INDESIT company

Model type:
LI620

Commercial code:
F029511

n1045069: Modification of racks and dispenser lid on EVO3 dishwashers

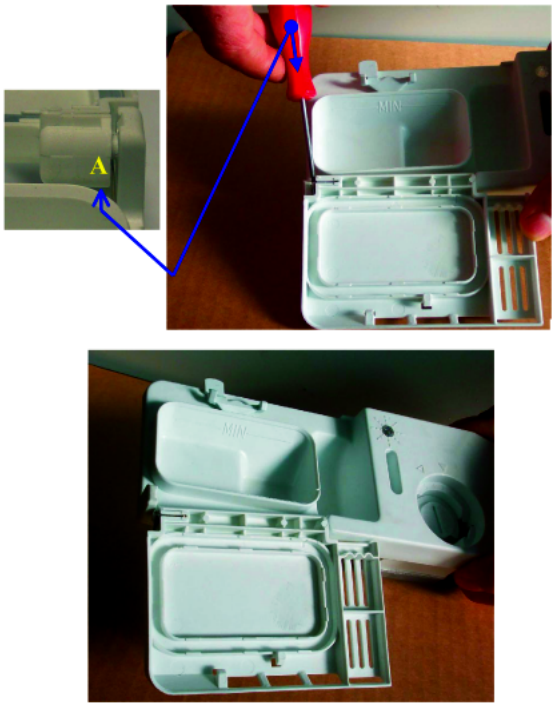
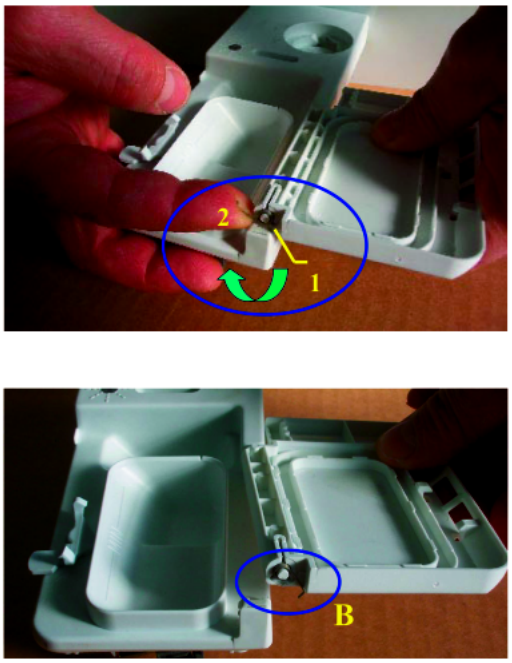
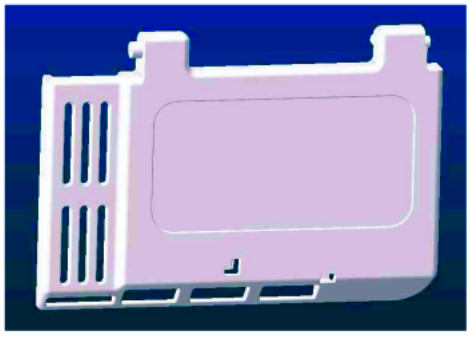
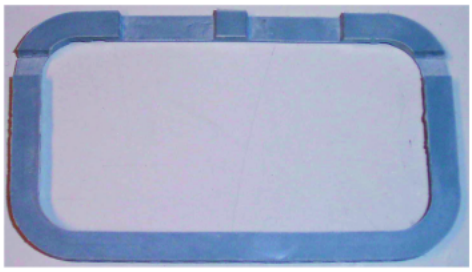
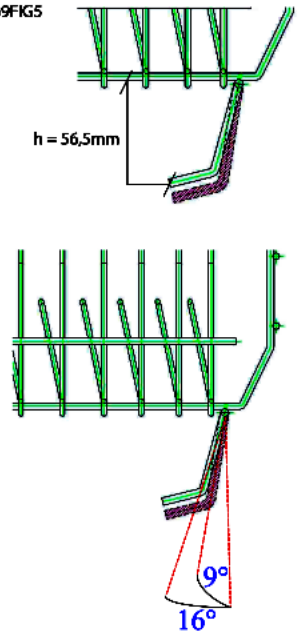
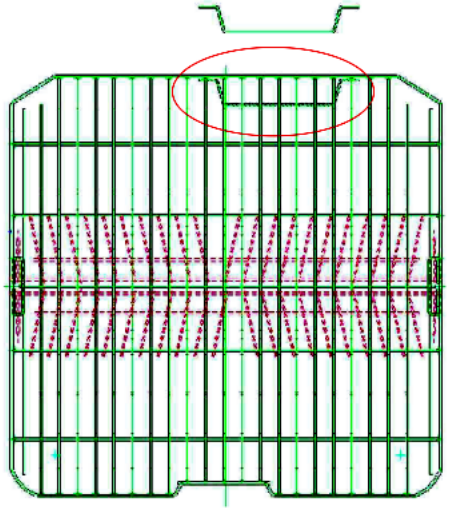
To obtain better dissolving of the detergent during the wash cycle, the following modifications have been made to EVO3 dishwashers:
- new dispenser lid, replacement code 098134 (see figure N1045069FIG4) created;
- upper racks modified with lid catch angle changed from 9° to 16° (see figure N1045069FIG5);
- MultiSystem lower racks modified with insertion of a spacer wire at the electric dispenser (see figure N1045069FIG6).

Lid installation instructions:
1) prise the lid out of the dispenser seat using a small screwdriver at point A (figure N1045069FIG1);
2) replace the lid, checking that release spring B (figure N1045069FIG2) is in place; before fitting the new lid load the spring from position 1 to position 2 (figure N1045069FIG2);
3) fit the lid in its special seat and check for correct operation (figure N1045069FIG3).
Lid closing may be harder for the first few cycles after replacement, due to settling of the material.

The upper and lower racks have the same spare part codes as the premodification items; Replacements Warehouse stocks have been replaced.

N1045076FIG1

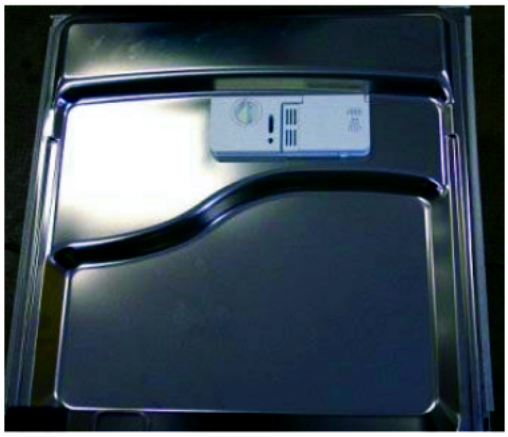
n1045076: Different position of electric distributor.

The position of the electric distributor has been changed as shown in the attached illustration.
The new machines have a new industrial code.

Introduced items:
C00108980 upper rack
C00109698 inside door

Premodification items:
C00094235 upper rack
C00095276 inside door

N1045078FIG1

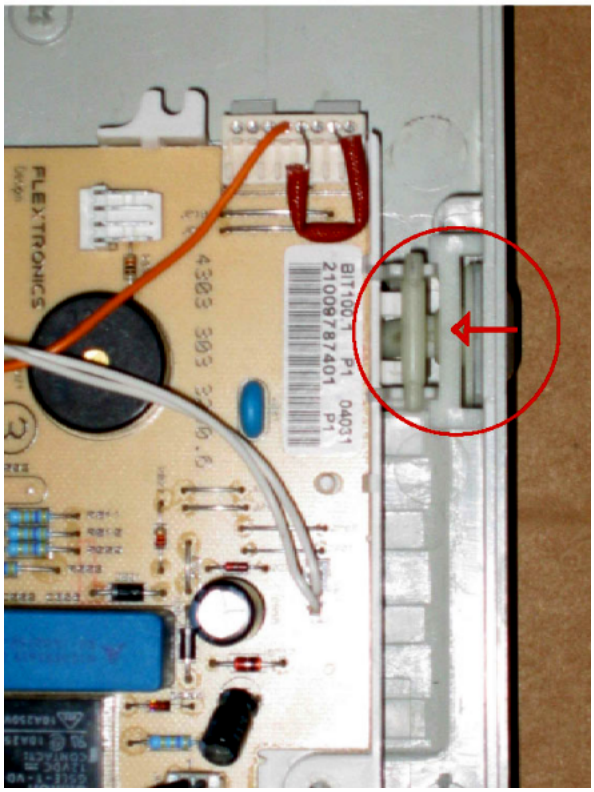
n1045078: Introduction of distance plug for button "P"

From serial no. 40406.0001, all dishwashers affected by this note have been equipped with a distance plug Service code 109844 in order to improve the mechanism of the "P" programme button (see N1045078FIG1).

N1045083FIG1

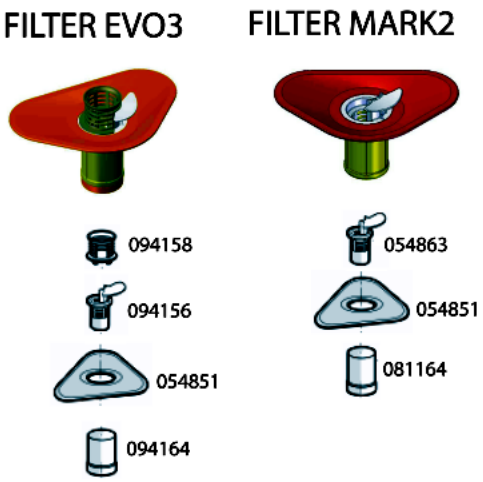
n1045083: Modification of filters on EVO3 60 cm dishwashers

All dishwasher models affected by this modification have been equipped with the items listed below, in order to solve the drain pump clooging problem.

Introduction of:
Cylindrical plastic filter code 081164
Central filter code 054863

Elimination of:
Cylindrical plastic filter code 094164
Central filter code 094156
Central filter grid code 094158

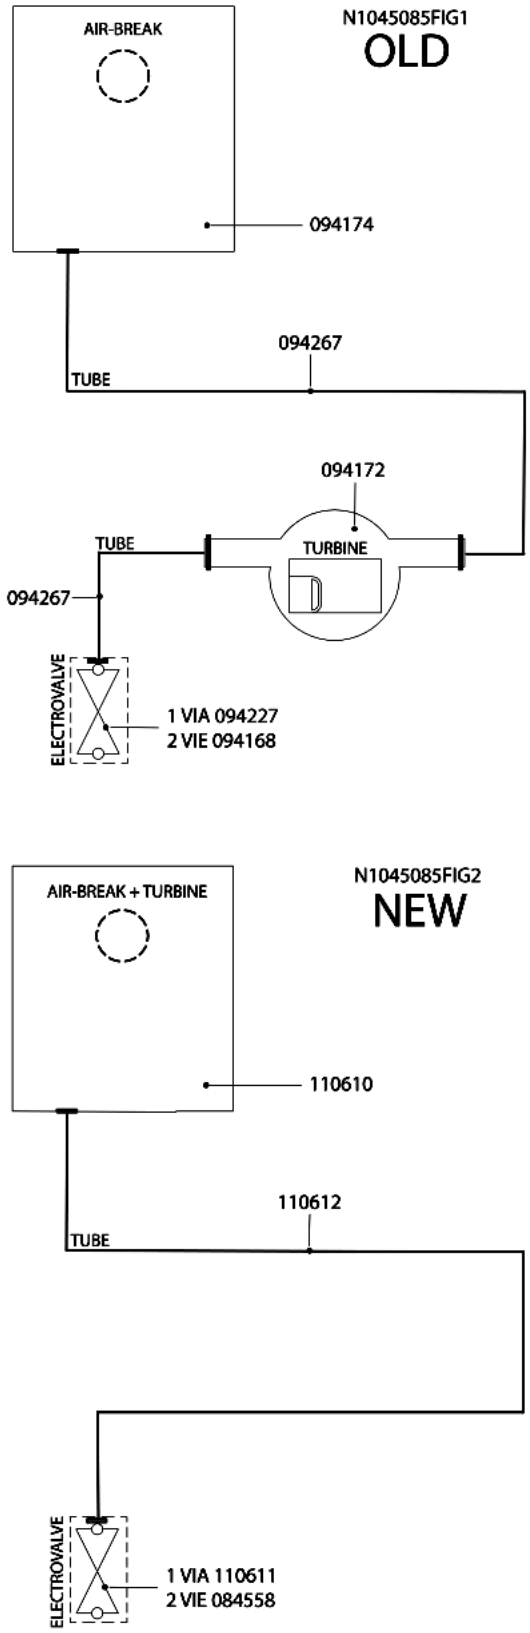
n1045085: Introduction of new litre counter turbine integrated on air-break.

All dishwashers affected by this note have been equipped with a new litre counter turbine on the air-break.
Picture N1045085FIG1 illustrates the premodification structure, picture N1045085FIG2 the new structure.

AIR-BREAK:
new 110610;
premodification 094174;
the new item features a new integrated litre counter turbine and its water supply hose has a smaller diameter.

SOLENOID VALVES:
new:
1-WAY code 110611;
2-WAY code 084558(Rohs 143737);
premodification:
1-WAY code 094227;
2-WAY code 094168;
the new solenoid valves have a smaller diameter drain hose fitting.

HOSES:
new solenoid valve hose/air-break code 110612;
premodification turbine hose/air-break code 094267;
premodification solenoid valve hose/air-break code 094267;
the new hose has a smaller internal diameter.

WIRING:
the litre counter turbine connecting cable is longer, but since the connector is the same, the new item can be used in place of the premodification one.

N1045133/134FIG1

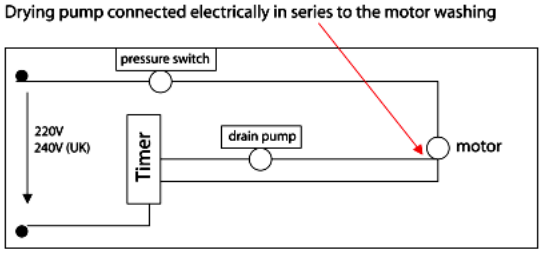
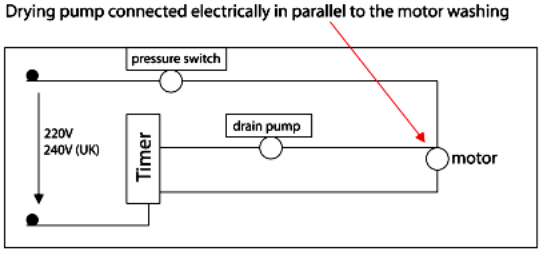
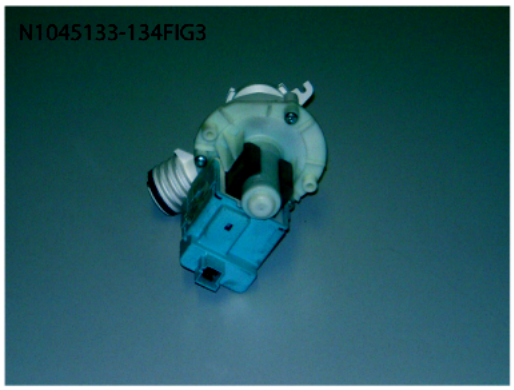
The drain pump electrical connection has been modified from a configuration in series with the wash electric pump to one in parallel.

The drain pump in series with the wash electric pump is fed through the wash electric pump causing a voltage drop equal to -15V (diagram N1045133-134FIG1).

The drain pump in series with the wash electric pump is electrically fed directly by the F-N line, without any voltage drop (diagram N1045133-134FIG1).

New parts:
Wiring in parallel
C00118767(Rohs 143766) - thermoprotected drain pump 220/240V 50HZ 26W - picture (N1045133-134FIG3)

Premodification parts:
Wiring in series
C00112306(Rohs 143739) - drain pump 230V 50HZ 22W - picture (N1045133-134FIG4)

Important!!
The thermoprotected drain pump cannot be installed on premodification dishwashers.
The non-thermoprotected drain pump cannot be installed on modified dishwashers.

N1045136FIG1

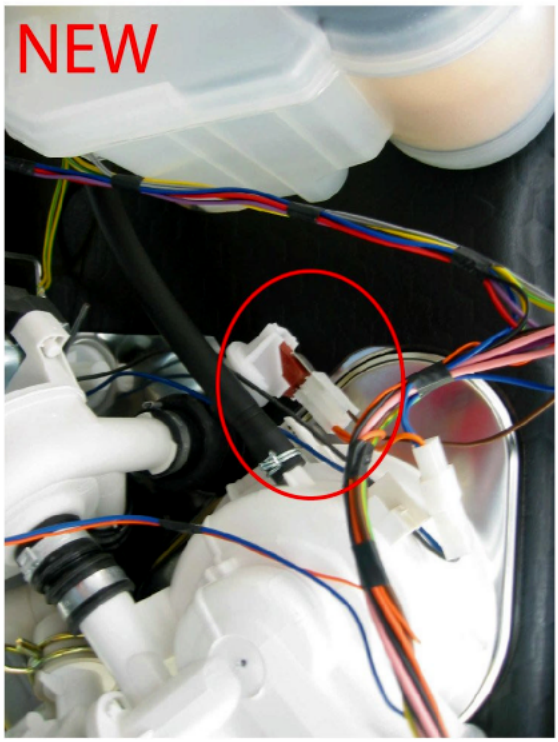
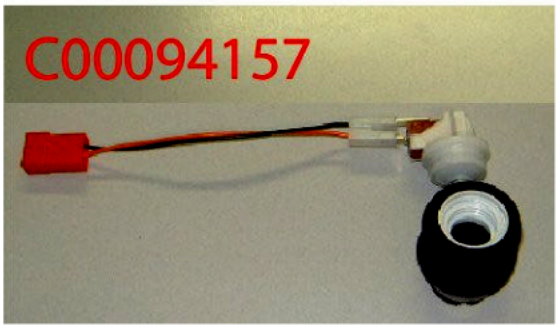
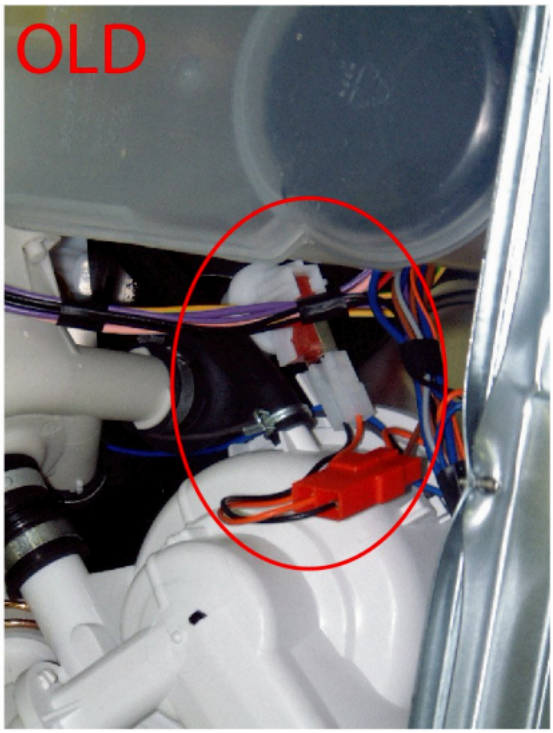
n1045136: introduction of new high pressure sensor

In modified products the connector going to the high pressure sensor is part of the wiring assembly (see picture N1045136FIG1).
In premodification products the high pressure sensor is connected to the wiring assembly by a cable that is part of code C00094157 (see pictures N1045136FIG2-3).

New parts
Wiring
C00142435 - high pressure sensor

Premodification parts
Wiring
C00094157 - high pressure sensor + cable

The new parts are not individually interchangeable with premodification ones.
